PLANNING BOARD

Tuesday, January 9, 2024 at 4:30 PM
Hybrid Meeting, Room 24 (Basement
Level of City Hall) and Zoom

- ii. Major Site Plan and Conditional Use; 19 West Street; Carleton West, LLC, Applicant. The Planning Board will hold a hybrid public hearing to consider a proposal to redevelop an 8,360 square foot medical office building as a five-unit residential building, and construct two separate duplex structures on a 0.86-acre property addressed at 19 West Street, with frontage on Carleton Street. The project also involves the construction of 18 new parking spaces, and would further retain 23 existing parking spaces for use by neighborhood residents. The property is zoned R-6 residential, and is also located within the West End Historic District. A project and plan summary are available for viewing on the city's CSS Portal (<https://css.portlandmaine.gov/>) by referencing Plan Number PL-002614-2023 and CU-002693-2023.

PROJECT: WEST STREET REDEVELOPMENT
19 WEST STREET, PORTLAND, ME
SHEET TITLE: LANDSCAPE PLAN
CLIENT: CARLETON WEST, LLC
9 GOULD ROAD
LEWISTON, ME 04240
DATE: 8/4/2023
SCALE: 1" = 10'
JOB NO: 23-020
SHEET: L-1.0

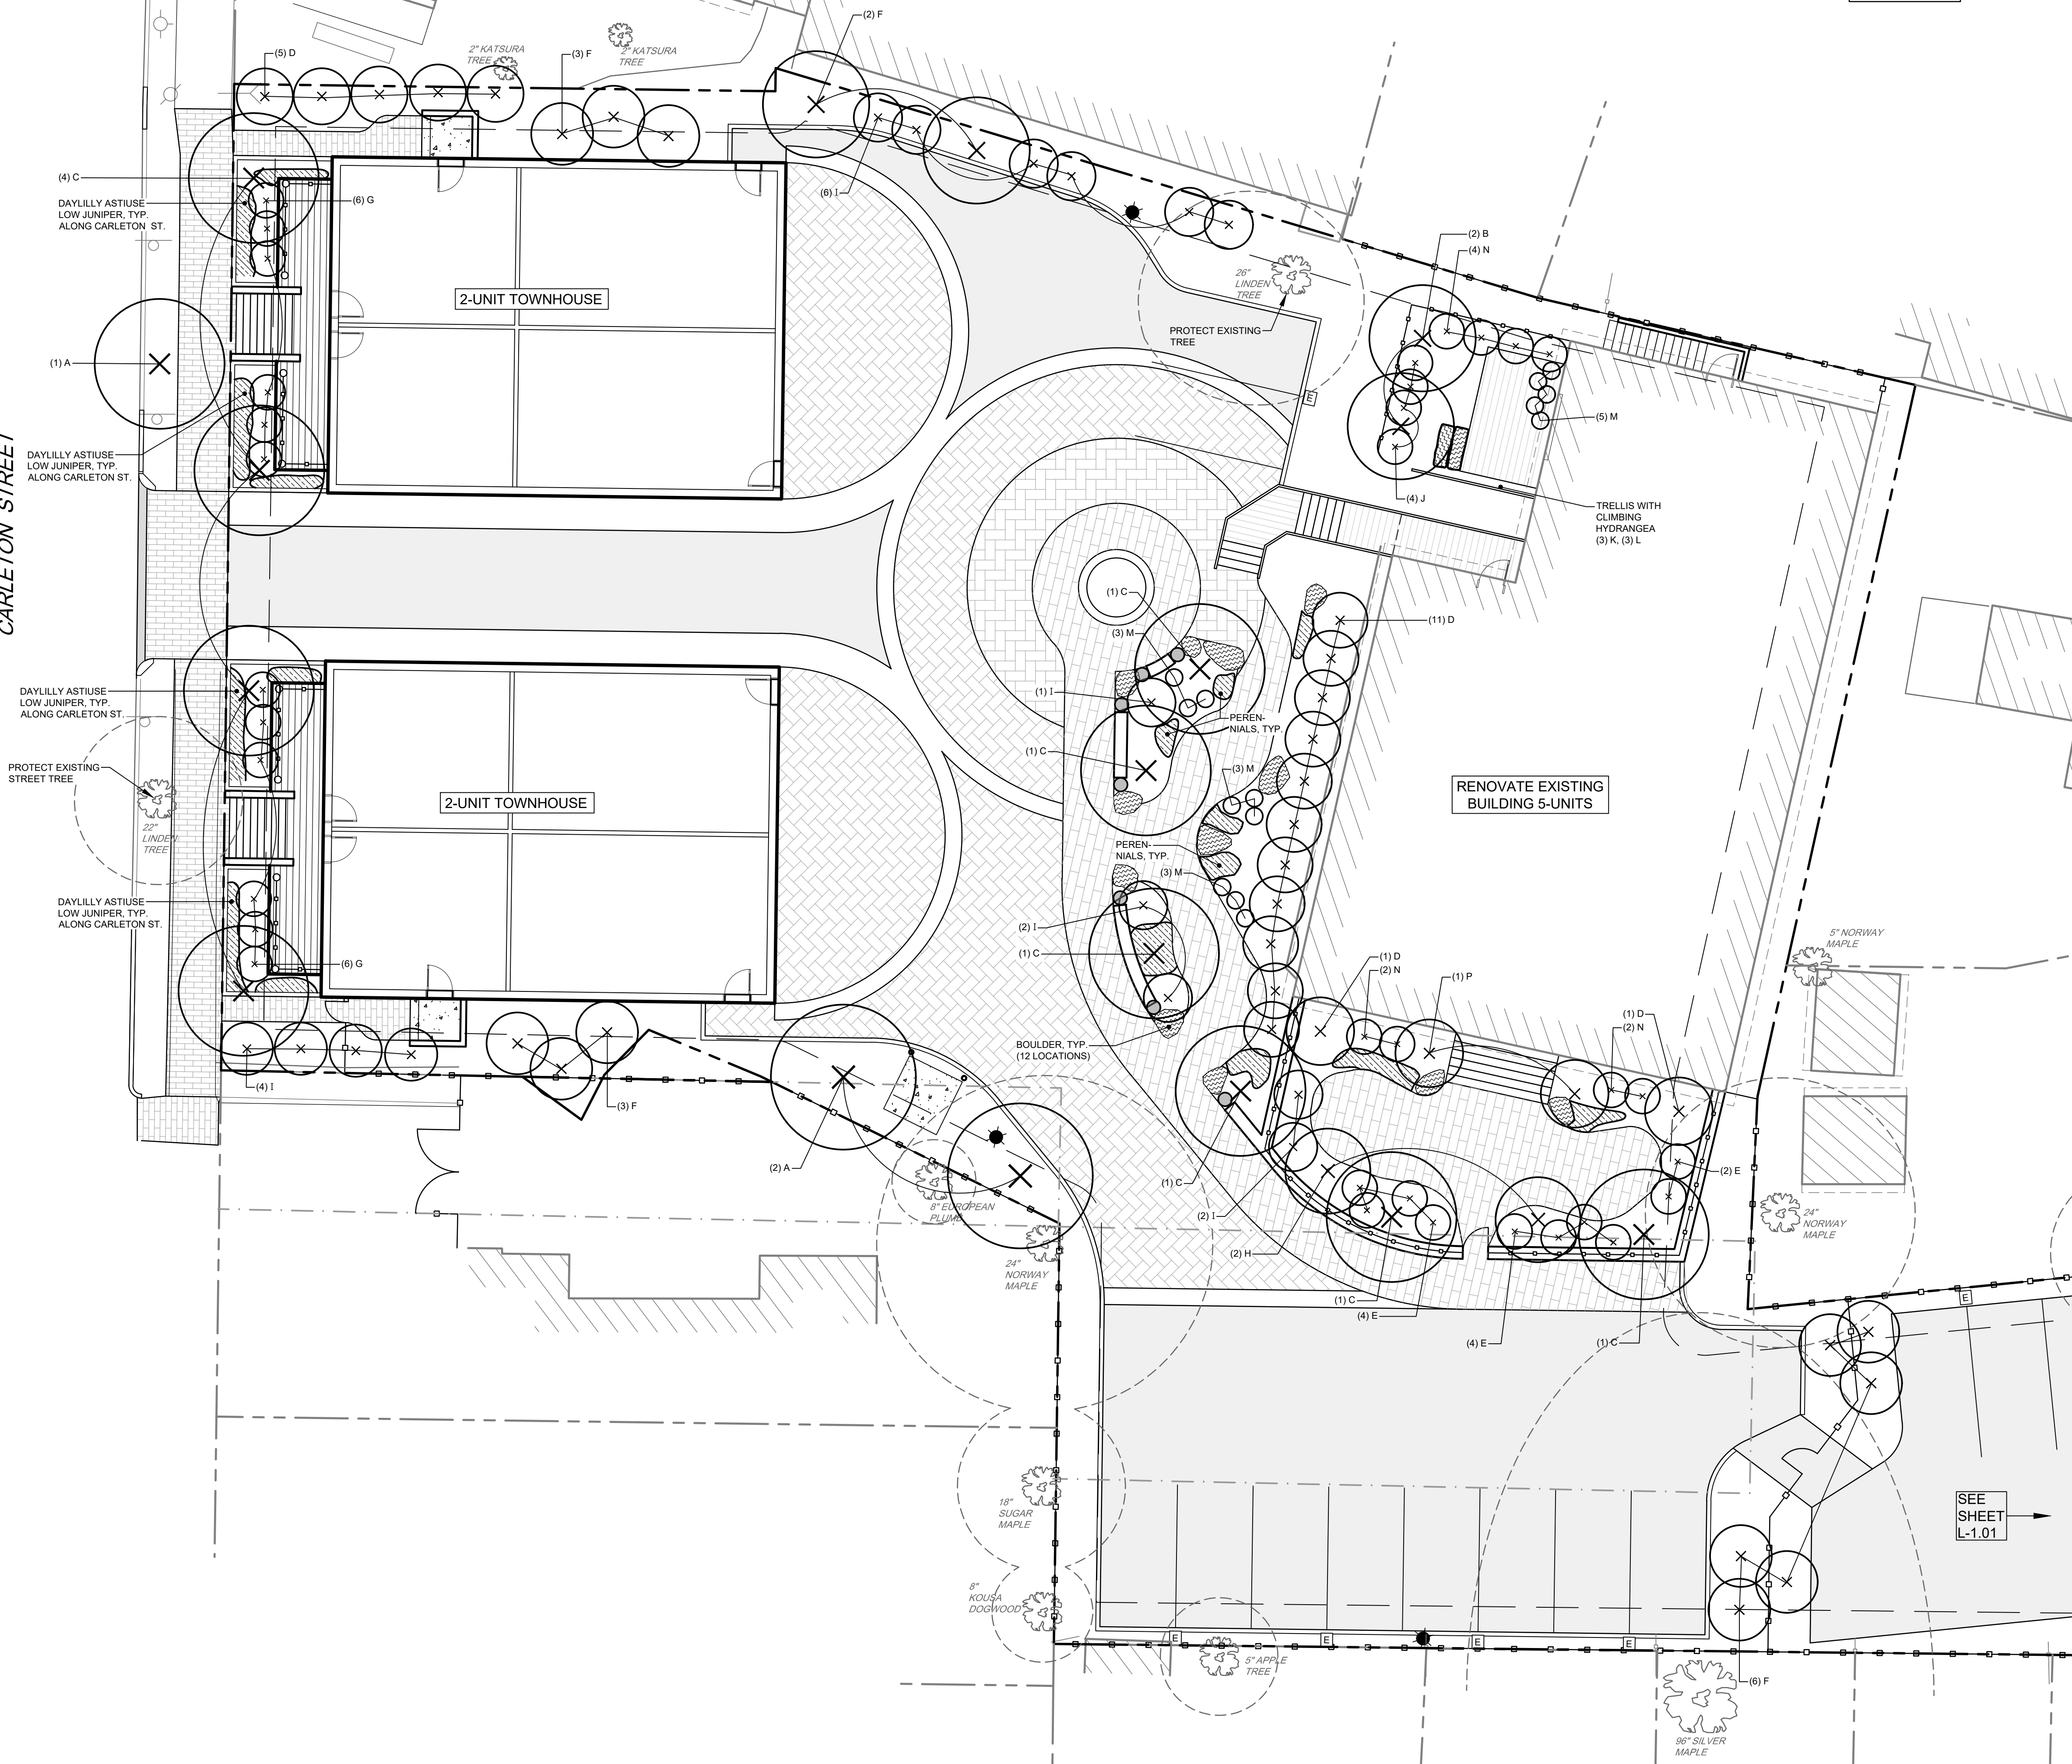
- Sheet L1.0 - The *Tilia americana* species proposed for street tree placement - department would require a fastigiat cultivar that would not exceed 30' canopy dia to reduce overhead line conflicts.

- Sheet L 1.0 - Ensure proper spacing is provided for mature forms of plant materials, and provide further cultivar information if a plant with specific habit or size is being proposed that is notably different from the straight species cultivar. Some species, like the myrica plantings, appear to be densely spaced and in confined locations that will require more frequent maintenance to ensure mature size tendencies of the species does not overgrown or negatively impact adjacent plantings, pathways, or other areas.

- Sheet L 1.0 - Any fruiting species planting overwalks and near entrances will increase slipping hazards or tracking of crush fruits inside buildings, while not required to be substituted by statute, applicant is encouraged to be aware of those issues and select species with smaller fruits or no fruits to reduce those issues, or anticipate that in property maintenance planning.

- Sheet L 1.0 / General comment-Cornus Mas plant symbol in plans does not accurately represent full canopy size of a small tree, if applicant intends to utilize plantings as a hedge, a clarifying note would be beneficial.

Revised Plans: L-1.0, L-1.1

Revised Plans: L-1.0

Revised Plans: L-1.0, L-1.1

Revised Plans: L-1.0
